## CITY PLANNING COMMISSION

PROPOSAL: The applicant is requesting the necessary entitlements to convert an existing 38,400 square foot office/warehouse structure in a C-4 zone into 100 percent office use.

MEETING DATE October 13, 1983

CPC ITEM NO. 22

EXHIBIT B

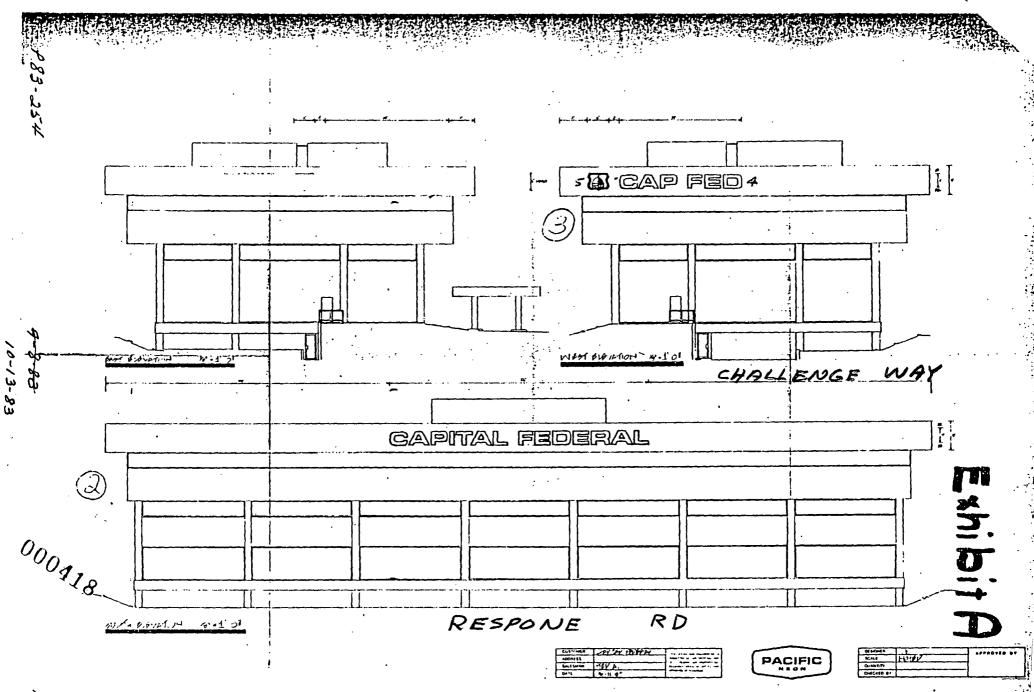
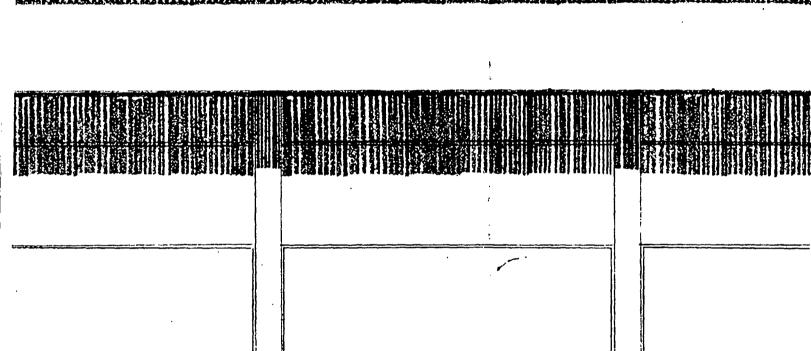
- 1. Only one of the revised signs exceed the current Point West Guidelines standards for attached signage. The larger of the two signs, which measures 55'6" x 2'9" exceeds the dimension and area requirements by only 5± feet in length and 3± square feet in area. Staff finds the proposed dimensions and areas acceptable because the sign is still in scale with the building.
- 2. The Point West Guidelines currently permit, one attached sign per parcel. Staff does not object to the two proposed signs since the subject parcel has two frontages.
- 3. The Sign Ordinance sets forth certain conditions which must be satisfied to warrant the granting of a variance.

- a. Only two attached signs shall be permitted. These two signs shall consist of the following:
  - one LOGO and "CAP FED" sign of a total length of 35 feet and areas of 108± square feet; and
  - one "Capital Federal" sign of a total length of 55± feet and areas of 161± square feet.
